# UNITED STATES PATENT AND TRADEMARK OFFICE

APPLICATION NO.	FILING DATE	FIRST NAMED INVENTOR	ATTORNEY DOCKET NO.	CONFIRMATION NO.
10/723,114	11/26/2003	Anand Hariraj Udupa	TI-37239	1319

<b>Office Action Summary</b>	<b>Application No.</b> 10/723,114	<b>Applicant(s)</b> UDUPA ET AL.	
	<b>Examiner</b> Leonardo Andújar	<b>Art Unit</b> 2826

**DETAILED ACTION*****Claim Rejections - 35 USC § 102***

*FIG. 7C*

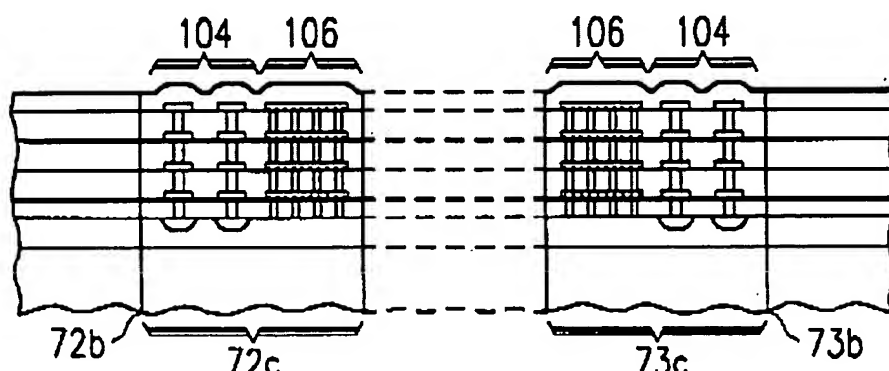
3. Regarding claims 1 and 10, Ibnabdeljalil (e.g. fig. 7A-C) shows an integrated circuit 73a; a first scribe seal 104 around the integrated circuit; and a second seal 106 around the first scribe seal wherein all of the integrated circuit, the first scribe and the second scribe seal are laid on a common substrate. Regarding claim 10, device of claim 1 would necessarily have to be formed in order to function. Claim 10 fails to further limit the devices of claim 1 other than simply form each of their components.

7. Regarding claims 5 and 14, Ibnabdeljalil (e.g. fig. 7C) teaches that the second scribe seal comprise a thick metal layer providing mechanical strength to the die wherein the thick metal layer is not connected to the common substrate provide high resistance path to the common substrate (col. 3/lls. 14-30; col. 7/lls. 9-23 & col. 12/lls. 26-39). Regarding claim 14, device of claim 5 would necessarily have to be formed in
